NOTICE OF PUBLIC HEARING **Minor Variance**

APPLICATION NO.: FL/A-21:204

SUBJECT PROPERTY: Municipal address **198 Victoria St., Flamborough**

PROPOSAL: To permit a lot to be retained (shown as Lot 2 pursuant to Consent Application File Nos. FL/B-21:43 and FL/B-21:44) containing an existing single detached dwelling, an existing accessory building (garage) and an existing above ground swimming pool and to permit two (2) lots to be conveyed (shown as Lot 1 pursuant to Consent Application File No. FL/B-21:43 and shown as Lot 3 pursuant to Consent Application File No. FL/B-21:44) to contain a single detached dwelling on each lot notwithstanding that:

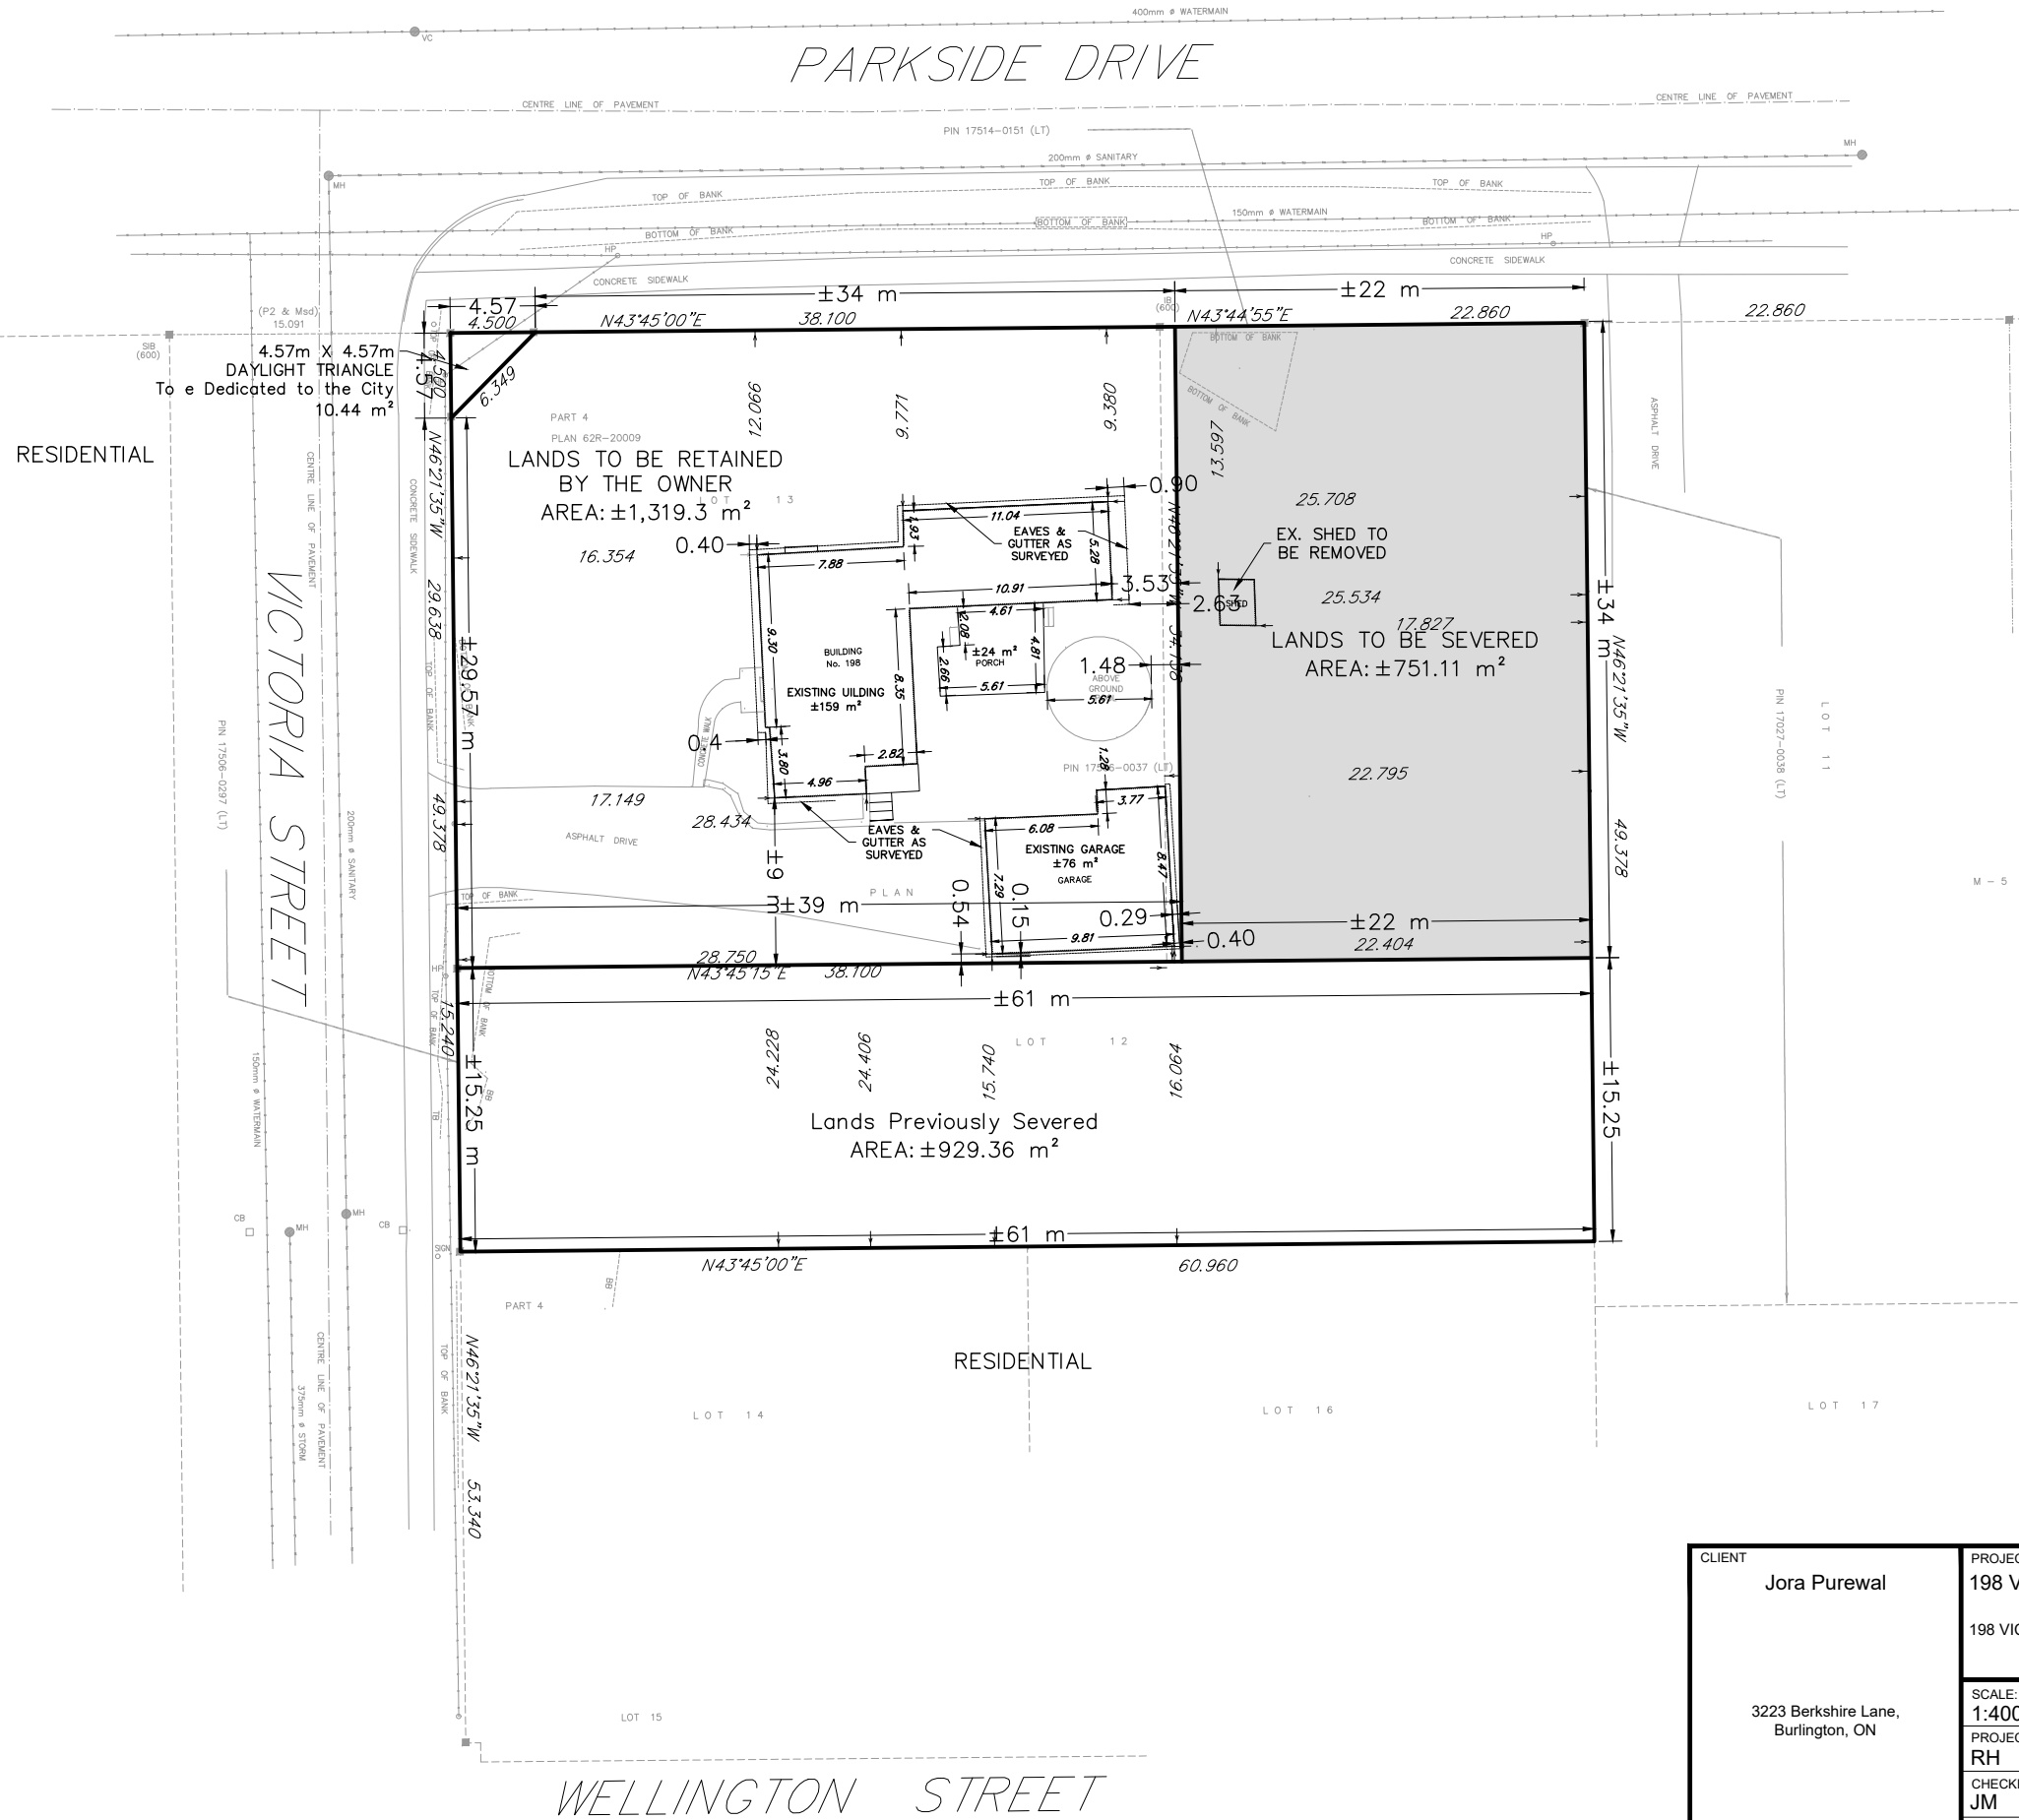
1. The Consent to Sever - Sketch 1 submitted does not show the road widening or daylight triangle intended to be incorporated into the road allowance as shown on the Site Plan (Revision # 2 dated 2021-06-14) submitted with Minor Variance File No. HM/A-21:204.

During the hearing we confirmed our support for the revised Transportation Planning staff comments which required a 4.57 m x 4.57 m daylight triangle at the Parkside Drive and Victoria Street intersection, and no other Right-of-Way dedications (**see Attachment B**). We also engaged in discussion with Committee members at the hearing regarding tree retention and committed to tabling the application so that we could review the comments and consider preparing something to address this issue.
